Monitoring Report

- 1). **Name of Project:** Electrification of Remaining Areas in AJK District Mirpur-III
- 2). **Sector:** Power
- 3). **Sub-Sector:** Electricity
- 4). **Unique Ref. No:** POW#149
- 5). **Location:** District Mirpur AJK

Issues in PC-I

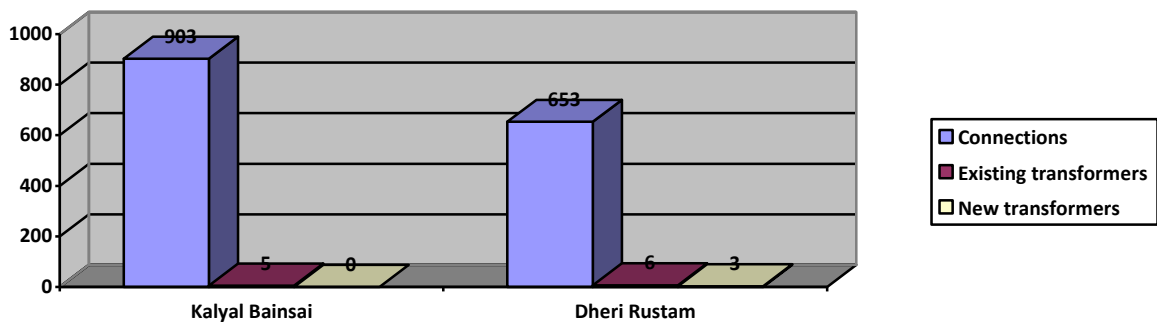
1. The PC-I documents were examined and a lot of discrepancies, deviation and irrationalities were found contradicting to the ground realities while:
 - i. The Ratta village had 1117 service connections till June, 2013. The number of installed transformers in the said village were only 5, which were insufficient to cater the needs of the village. Besides, no more transformer is allocated in this scheme for the said village.
 - ii. The existing infrastructure of Jari village had 28 service connections with 6 transformers till June, 2013 whereas the electricity department allocated another transformer to the said village. A comparison of Ratta village and Jari village can be seen in the table below:

1. The PC-I preparation is irrational and needs to be justified as lot of discrepancies are found in the allocation of transformers and connections without considering the needs of the people. Electricity department should probe this nonprofessional behavior and fix the responsibility along with disciplinary action.
2. All queries made in the above section “Issues in PC-I” should be justified point by point.
3. Solid Feasibility study should be done on real need basis.
4. It should be asked from Electricity Department that why PC-I of the Scheme was not prepared by keeping in view of next 10-15 years’ needs of the people?

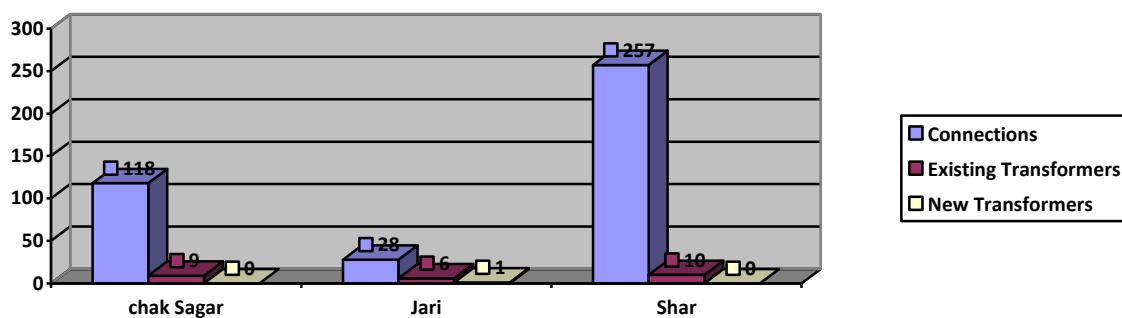
iv. The Kalyal Bansi village has 903 connections and 5 transformers while Deri Rustam has 653 connections and 6 transformers. Dheri Bansi is allocated with 3 new transformers of 50 KVA in the PC-I contrary to Kalyal Bansi which has more connections. It can be viewed by the graph below:

Pictorial View of Site

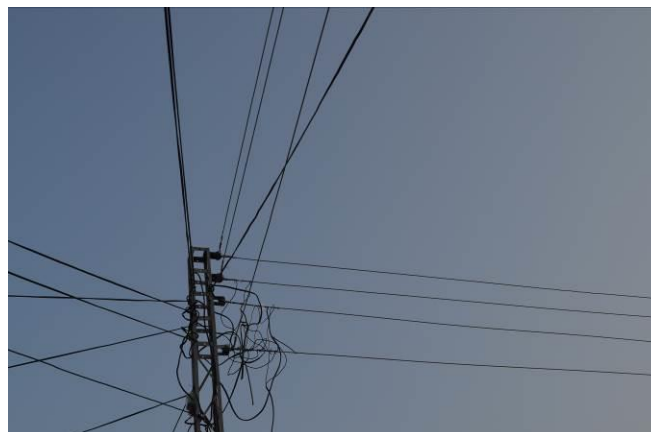
1. Poor concrete finishing was found during the monitoring visit.

2. Rusting was found in several HT and LT poles.

3. Four conductor distribution lines were continued by the 3 conductors while at some locations, two conductor lines were used for distribution.

4. In distribution transmission line at bypass road an insulator was missing on a pole.

5. During the visit, almost 40 LT poles were observed and all were found without any specific reference number.

6. Mostly the poles were without proper earthing.

7. Broken X cross of the poles were seen during the monitoring visit.

8. Angle of the pole was not accurate. The HT pole was found at obtuse angle with respect to ground.

5. Tendering and purchasing of equipment for development schemes should be done separately.
6. Electricity Department should take notice against poor quality of poles and response/action taken should be submitted to P&DD accordingly.

10. The Electricity Department should make it compulsory to mention pole serial number along with purchase order number on each pole during tendering process. The Electricity Department must not accept the poles from supplier without serial number along with purchase order. Furthermore, it must be ensured that poles purchase order number should be clearly visible on each pole even after installation.
